Field Safety Notice

FSCA identifier: 2014-74

Description: Zimmer® Universal Power System Handpieces

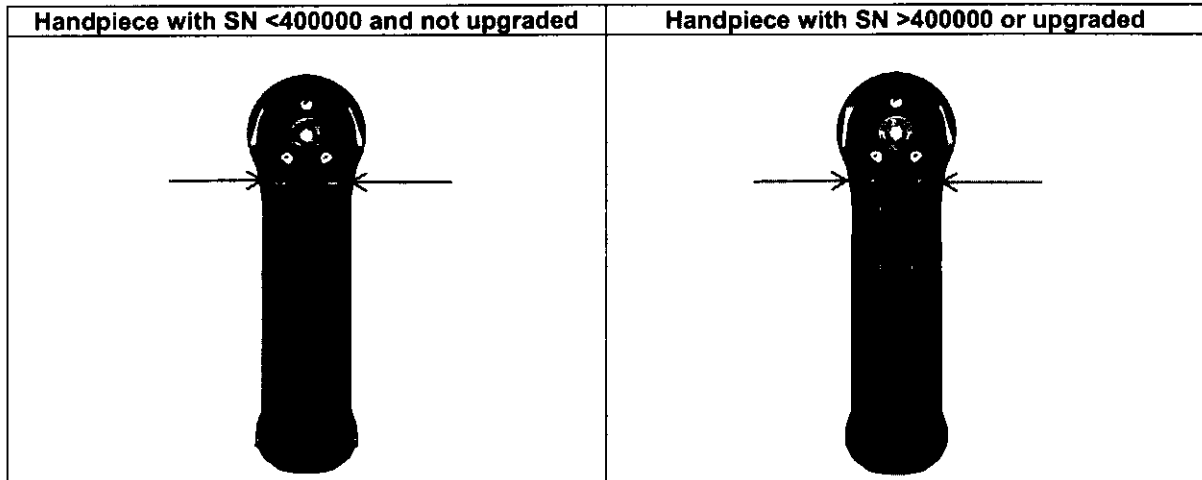
All Zimmer Universal Power System handpieces with serial numbers starting at 400000 and above are manufactured with new electronics. With the new electronics, the "self-start" issue is prevented from happening. In addition to the serial number, a visual indicator that the handpiece has upgraded electronics is the Safety Switch located next to the trigger mechanism. If it is tapered as shown in the below figure the device has the new electronics.

In addition to this field safety action, we will upgrade your device(s) with the new electronics that are used in the serial numbers >400000. This upgrade will happen during the annual preventive maintenance of your device. During that preventive maintenance we will also check and possibly exchange other components as appropriate. Zimmer would like to remind you that the Universal Power System should be returned every twelve months for inspection and preventive maintenance, as indicated in the Instructions for Use.
